REVIEW	ISSUE	EVENT
25-03-2023		
GRAHAM		
NMANDD		
NEWRY		
TRAFFIC MANAGEMENT DETAILS		
TM SETUP FOR PARADE		
1-ARE ADVANCED NOTICE SIGNINGS SHOWN?		Y/N
2-ARE RELEVANT DECLAMERS SHOWN?		Y
3-ARE PONT LOCATIONS SHOWN?		Y
4-ARE PONT LOCATIONS SHOWN AT ROAD CLOSED SIGNS?		N/A
5-ARE MARSHALL LOCATIONS SHOWN AT ROAD CLOSED SIGNS?		Y
6-ARE MARSHALL LOCATIONS SHOWN AT CENTRE LINE SIGNS?		N/A
PSNI		
1-Marshalls at Road Closed Signs		
2-Marshalls to advise motorists of permitted movements - Le		
3-Marshalls to advise motorists of permitted movements - Le		
4-Marshalls to advise motorists of permitted movements - Le		
5-Marshalls to advise motorists of permitted movements - Le		
6-Marshalls to advise motorists of permitted movements - Le		
7-Marshalls to advise motorists of permitted movements - Le		
8-Marshalls to advise motorists of permitted movements - Le		
9-Marshalls to advise motorists of permitted movements - Le

10-Marshalls to advise motorists of permitted movements - Le		
EVENT ORGANISER		
EVENT TRAFFIC MANAGEMENT DOES NOT COMPLY WITH CH 8 PLEASE REFER TO CLAUSE 2.3 OF OUR TERMS OF BUSINESS FOR FURTHER INFORMATION		
N.T.S	1601/2023	CA
NEWRY ST PATRICKS PARADE - 01		
0

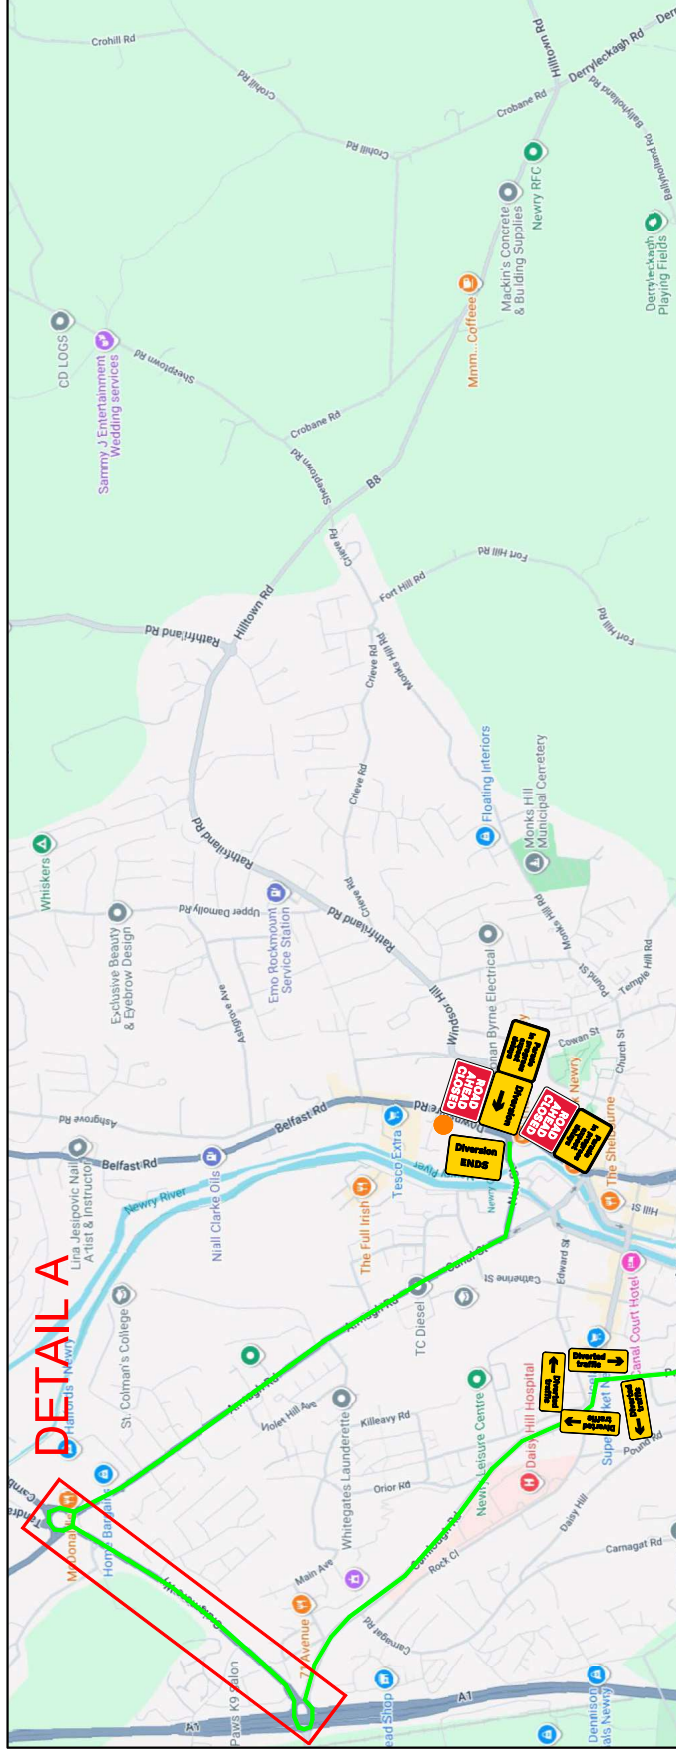
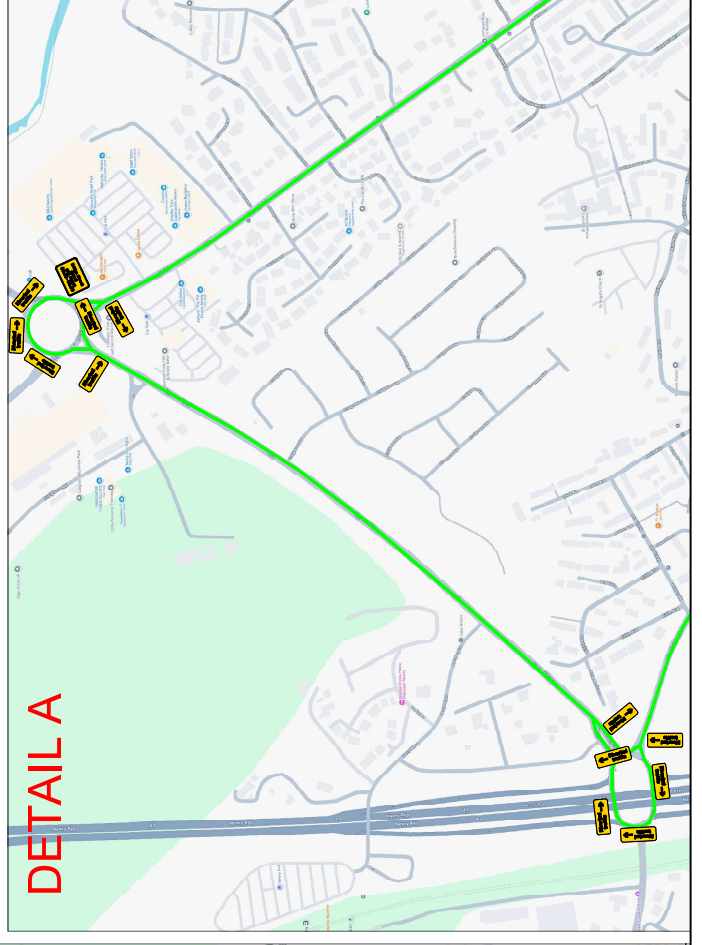
DATE/TIME	REVIEW	EVENT
BOOKET	NMANDD	
FILE	NEWRY	
	TRAFFIC MANAGEMENT DETAILS TM SETUP FOR PARADE	
DATA SHEET	Y/N	
	1- ARE ADVANCED NOTICE SIGNMANS SHOWN?	Y
	2- ARE RELEVANT DISCLAIMERS SHOWN?	Y
	3- ARE PSNI LOCATIONS SHOWN?	N/A
	4- ARE MARSHALL LOCATIONS SHOWN AT ROAD CLOSED	Y
	5- ARE MARSHALL LOCATIONS SHOWN AT CENTRE LINE CROSSING?	N/A
601	PSNI ● Marshalls at Road Closed Signs (Marshalls to advise motorists of permitted movements - i.e no vehicles allowed onto mainline route from a side street) ● Marshalls to advise motorists of permitted movements - i.e vehicles from side streets only allowed to turn left)	
602-603	EVENT ORGANISER	
	EVENT TRAFFIC MANAGEMENT DOES NOT COMPLY WITH CEN 789 AND/OR CLAUSE 2.5 OF CEN 789. THE FOLLOWING IS A SUMMARY OF THE TERMS OF BUSINESS FOR FURTHER INFORMATION.	
NAME	DATE	SIGNATURE
NITLS	19/07/2026	CA
Stamp & Title		SR
	A3	
	NEWRY ST PATRICKS PARADE - 03	0
